Faro Mine Complex

2012 Annual Geotechnical Review

March 28, 2013

Faro Mine Complex
2012 Annual Geotechnical Review

FIGURE 6

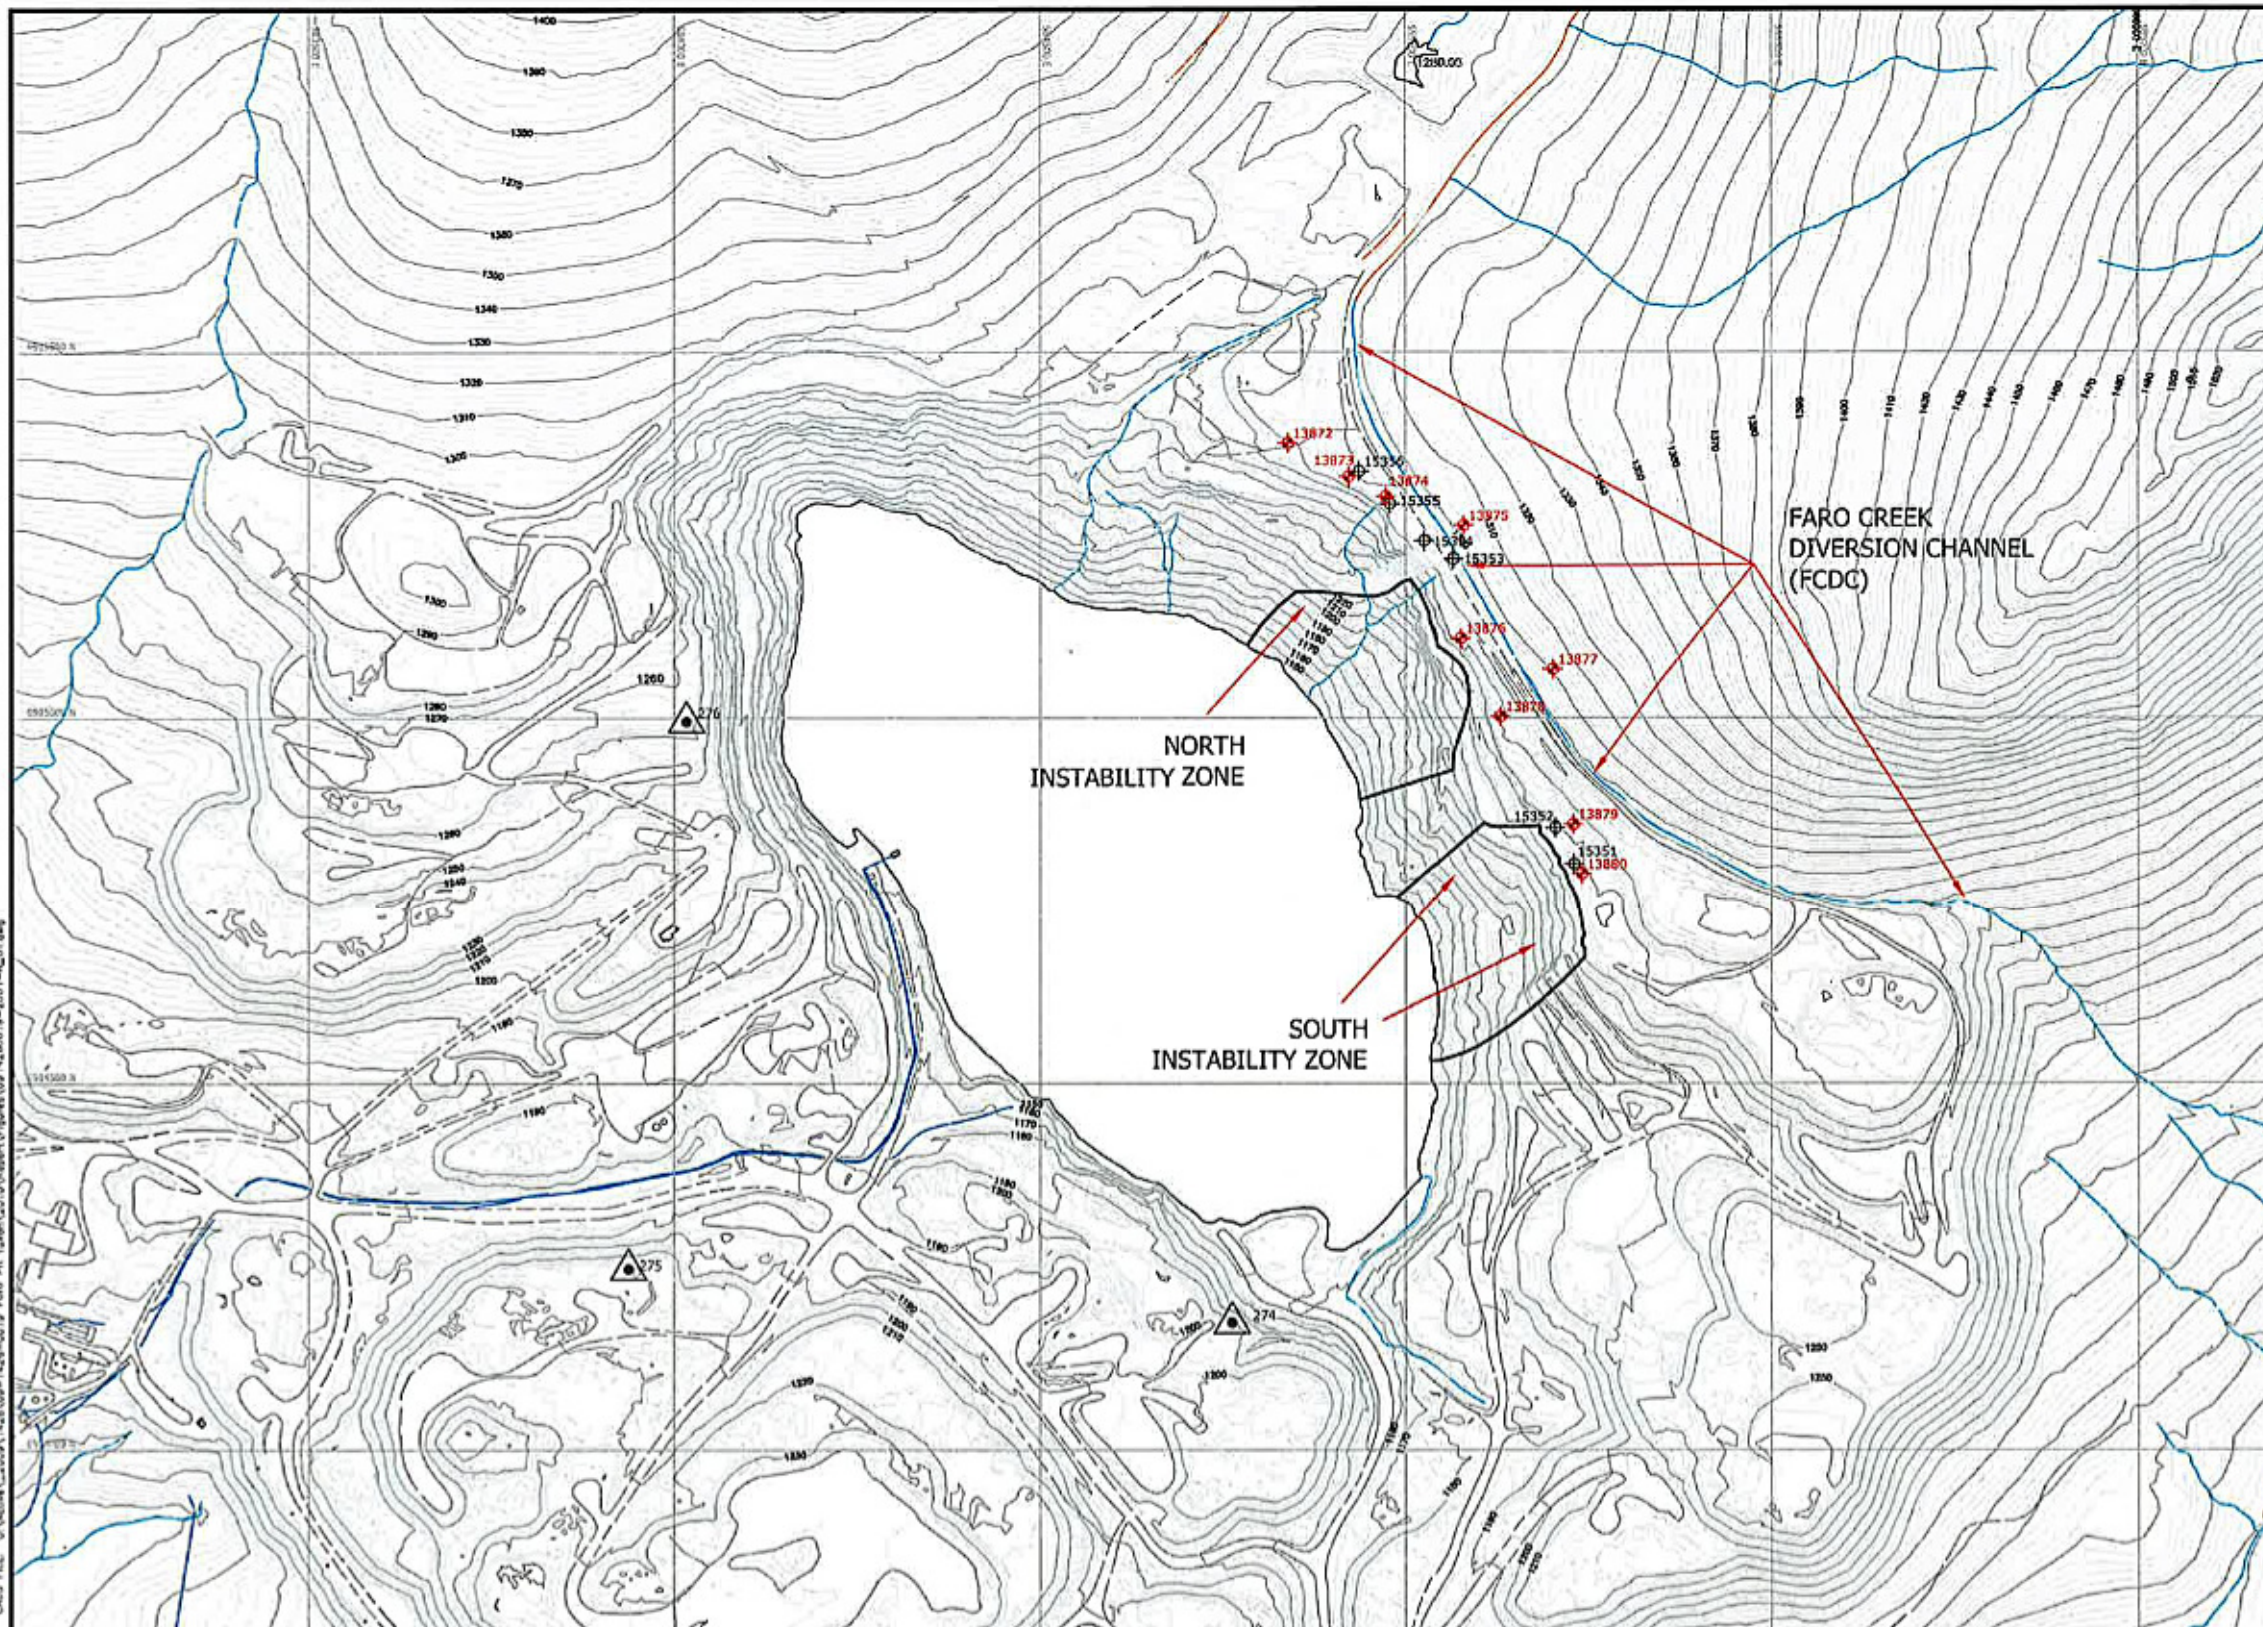
- Pit wall regression (Section II-A.2) – The measured relative distances between reference bars and the pit wall brim have been similar for four bars (#15352, #15354 to #15356) from 2008 to 2012, and for four newly installed bars (#13908, #15717, #15737 and #15742) from August 2011 to September 2012. Locations of the four new reference bars should be added on Figure 6 to aid interpretation. The apparent difference in readings of about 2 m for #15351 was attributed to potential error in the bearing of distance measurement (Golder 2011a). The ID tag for Reference bar #15353 was destroyed in September 2010. In 2011 Yukon Engineering Services re-tag the Reference bar with ID tag #13908. The reading for reference bar #13908 on May 28, 2012 apparently contains a transcription error. In general, with the exception of bar #15351, all measured distances are practically the same within measurement accuracy. The bearing issue of distance measurement for bar #15351 should be rectified in the field to remove the anomaly.

- Pit wall prism monitoring (Section II-A.3) – The ordinates of change in northing and easting for the prism monitoring plots should be “cm” instead of “m”. No survey was conducted in 2012. The scatter of the nine data points for the change in northing and easting plots seems to increase from 2 cm in October 2006 to 3 cm in August 2009. The scatter in the northing-change plot increases further to 5 cm in September 2010 and 2011, and the scatter in the easting-change plot remains at about 3 cm in August 2010 and 2011. It is uncertain whether these changes in scatter are related to prism position/survey accuracy issue or pit wall movement. Moreover, two prisms located uphill of the Faro Creek Diversion Channel (Points #13875 and 13877) were considered by Golder (2011a) not likely to move. However, they experienced “apparent change” of 2 cm to 3 cm in northing and 3 cm to 7 cm in easting from 2006 to 2011. The above observations may indicate that these “measured changes” could reflect the accuracy of these surveys rather than real pit wall movements.

- Continue surveying the prisms installed at the pit wall as a means to monitor the pit wall movements in the North and South Instability Zone.
- Remove the anomaly of reference-bar distance measurement for bar #15351.

FIGURE 14

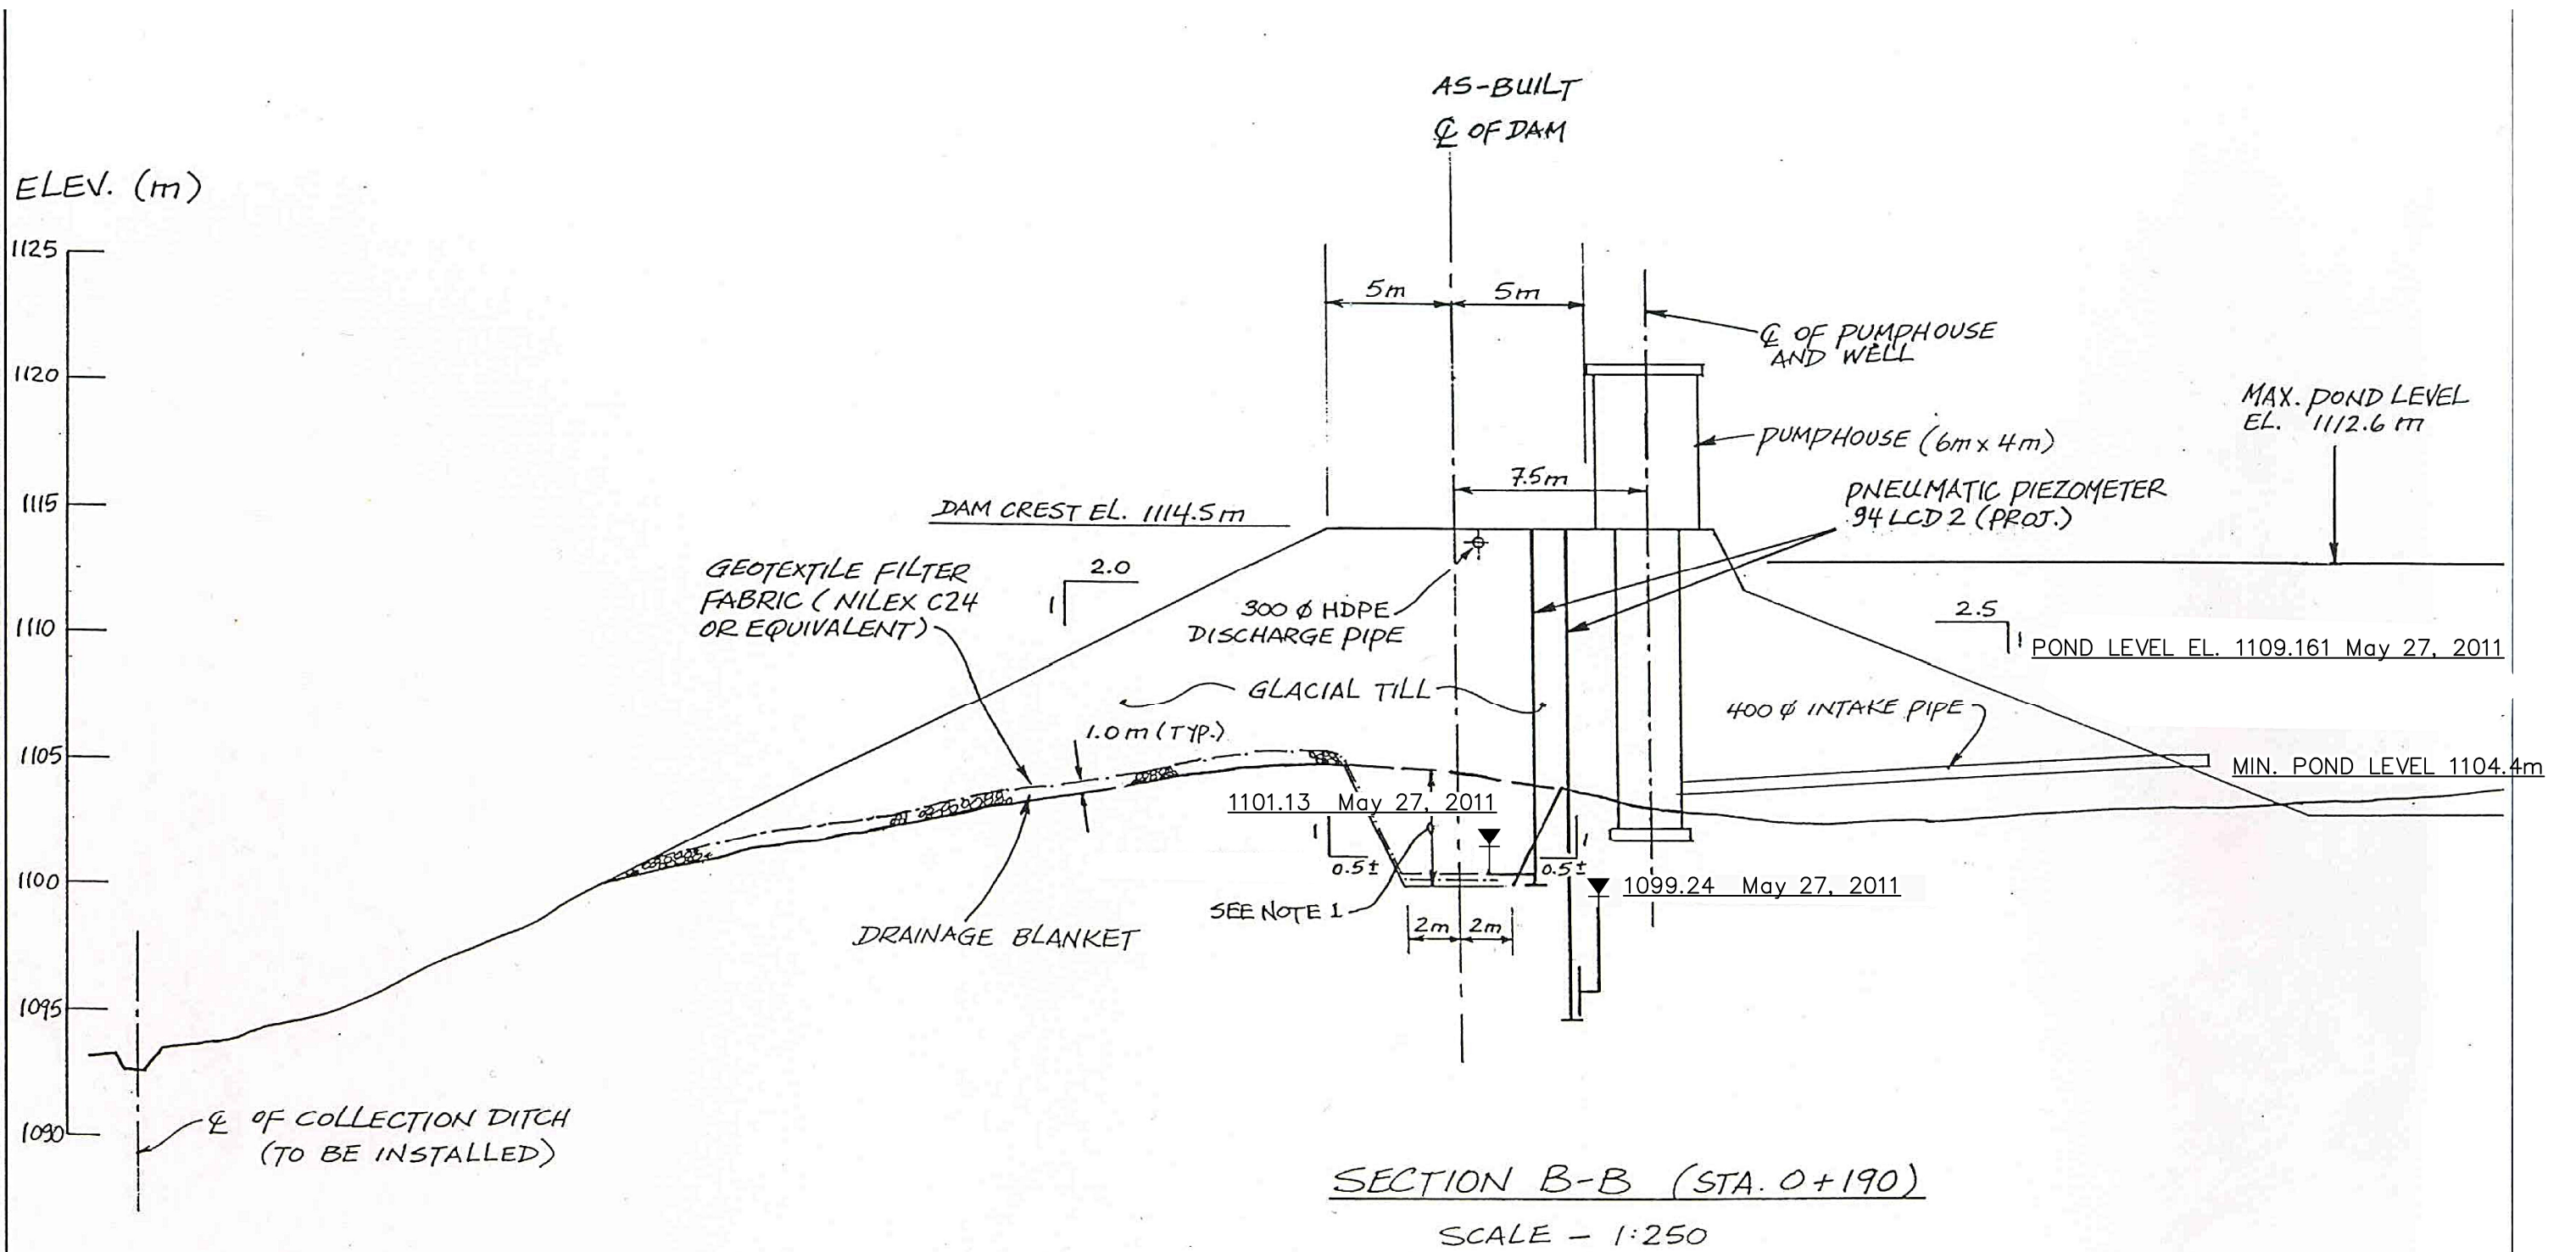
The Little Creek Dam is a homogeneous embankment dam constructed of local glacial till. It has a cutoff trench and a granular base drains downstream under the downstream slope (see Figure 14 for the dam section). The crest is about 10 m above natural ground, ranging in elevation from 1114.5 m to 1120 m. Side slopes are 2H:1V on the downstream side and 2.5H:1V on the upstream side. A zone of permafrost encountered at the south abutment was excavated prior to till placement. A 900 mm diameter, Corrugated Steel Pipe (CSP) emergency spillway is located at the south abutment (see Photos 101 to 103).
